Access Compliance Report Public Rights-of-Way (Curb Ramps)

Main Street: WELLINGTON_AVE Cross Street: PROSPECT_AVE Location: NW

ADA ID: RPRK220121142502 Ramp Type: Type 4 - Parallel Initial Pass/Fail: Pass Overall Compliance: No Severity Score: 25

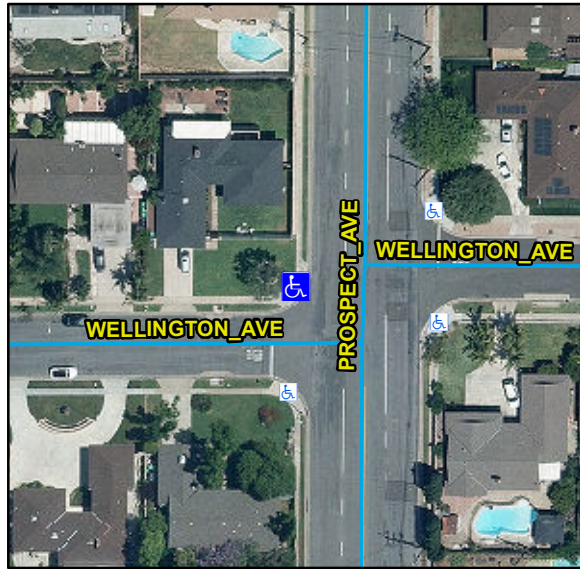
Crossing 1 Slope (%)	4.4		Crossing 2 Slope (%)	5.8
	Crossing 1 Cross Slope (%)	1.6		Crossing 2 Cross Slope (%)	1.4
Yes	Gutter Ponding	No	No	Curb Slope	9.2
No	Gutter Lip Height (in)	0.25		Road Run Slope (%)	2.5
No	Gutter Run Slope (%)	7.1		Road Cross Slope (%)	5.9
No	Gutter Cross Slope (%)	2.9	No	Perpendicular Joint Present	No
Yes	Overall Surface Condition	Acceptable			
	Cross Gutter Present?	No		Spandrel Present?	No
	Replace Cross Gutter?	N/A		Replace Spandrel?	N/A

Remove & Replace Curb Ramp With Two New Directional Ramps or Equivalent. Remove & Replace Gutter.
